DETAILED SITE PLAN

DSP-99048/01

STAFF REPORT

SUBJECT: Landy Property
Revision to Detailed Site Plan, DSP-99048/01

Unit Plans – Sheet 5

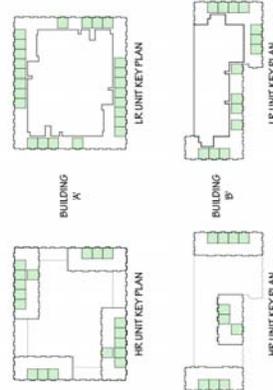
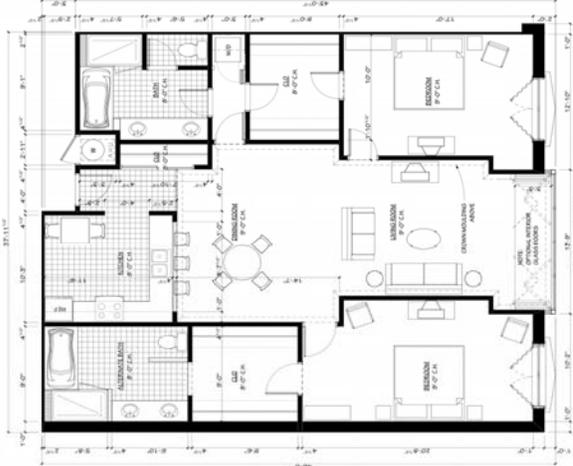
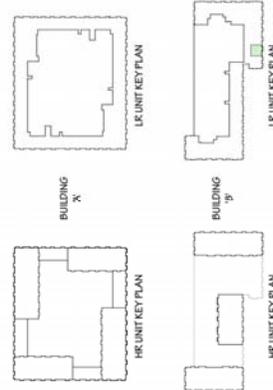
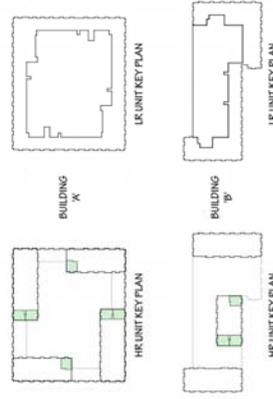
“Under the TDDP, three-bedroom units are only permitted when the property is developed as a condominium. Here, with the likelihood of future condominium development, the three bedroom interpretation of the 'den' feature adds a particular twist because when the building converts to condominium this will no longer be contrary to the Design Standard. Thus, based on the potential that this property will convert to condominium, thereby obviating the need for an amendment at all, and the fact that the 'dens' proposed will in fact be dens in a luxury unit rather than a bedroom, we respectfully request a waiver from Design Standard P39 to the extent that staff determines that this plan does not comply with said standard.”

Staff Comment: Staff agrees with the applicant’s proposal to allow three- and four-bedroom units without the provision of condominium ownership because of the uniqueness of the project and the limited use of these units within the project. There are 4 four-bedroom units, constituting only 0.33 percent of the project proposed as four bedrooms. There are 115 three-bedroom units proposed, which constitutes 9.5 percent of the units. The applicant’s argument that dens should not be counted as bedrooms is reasonable; there are no closets in the den, and most of the dens have wide openings, which would not make the unit suitable for the use of the room as sleeping quarters. The use of these units provides for a level of luxury in terms of unit size that has not been previously proposed within the county and it does not seem likely that the TDOZ standard in question requiring condominium ownership was intended to target this type of luxury unit.

FIGURE 1.

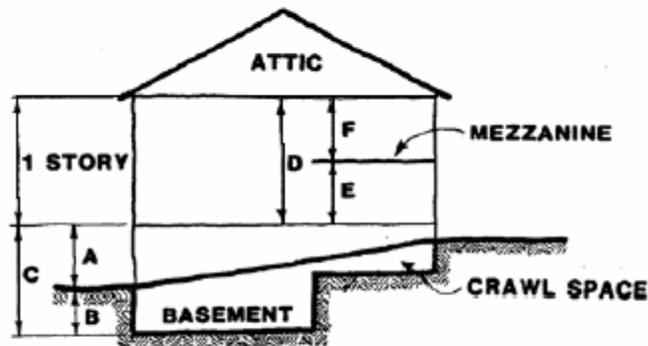
"Figure 1 of the Zoning Ordinance, as shown above, depicts a situation identical to what is proposed on the sixteenth story of the Landy towers. The main volume proposed is less than 20-ft high (at 18', 8"), and the proposed mezzanine floor area is never more than the required one-third (1/3) of the contiguous, open floor areas to which it is open below. In addition, the 2003 International Building Code (the MD State Building Code) has a strict definition and set of requirements for mezzanines that is consistent with the 1/3 area limitation stated in §27-107.01.(223) of the Prince George's County Zoning Ordinance. In IBC, mezzanines are not considered to be additional floor areas and exterior balconies have no occupancy load for egress purposes. The proposed unit design conforms to 2003 IBC requirements. The additional space proposed on the sixteenth story provides the units with striking, dramatic volumes and mezzanines that permit the owners the luxury of several options for utilizing the space."

Staff comment: Staff agrees with the applicant's legal argument that the use of a mezzanine at the 16th floor does not constitute a "story" per the definition of that term in the Zoning Ordinance. The building will appear to be 17 stories, if one counts the levels of windows on the outside of the building. However, the definition of "story" is difficult to refute, as the Zoning Ordinance is clear. Further, these units fulfill the intent of the requirements of the TDDP in that the sector plan demands that multifamily units developed in the transit district must demonstrate a certain level of luxury. The use of these penthouse units will provide a level of luxury beyond that normally found in multifamily development in the county.
